INTRODUCING THE NEW DEKK

HERCULES

SKIDSTEER RUBBER TRACK RANGE

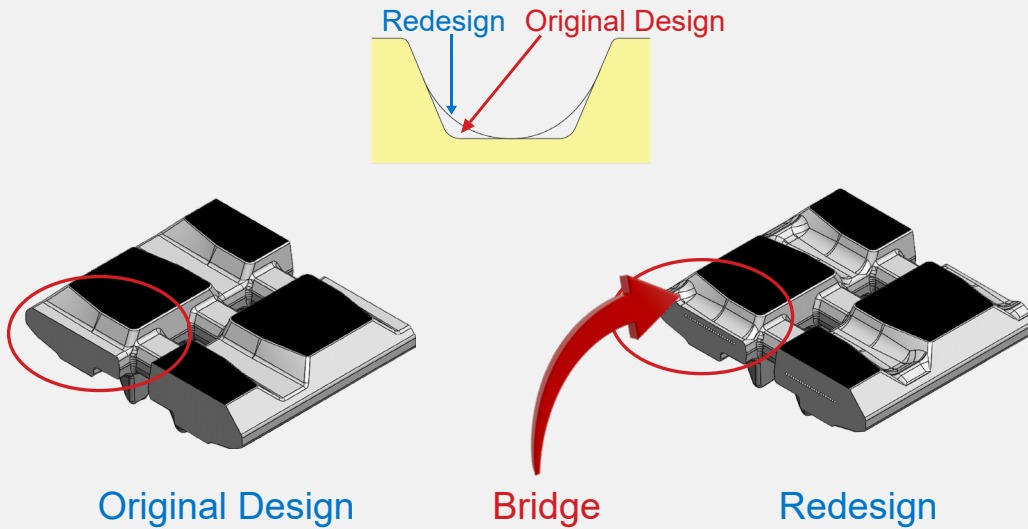
1 Redesigned the tread pattern by adding the Hercules Armour between the treads to absorb machine operating forces and protect the track from the outside. Resulting in a massive 16.5% decrease in stress on the track.

2 Redesigned the edge profile of the treads to reduce the concentrated force at the base of the treads to re-direct the force on the track and further protecting the core of the track

3 Upgraded reinforcement of the tracks by using a 15% higher tensile steel cable than other brands, further strengthening the carcass of the track.

4 Changed cable locations to deeper in the rubber and increased cable reinforcement to optimise overall structural integrity
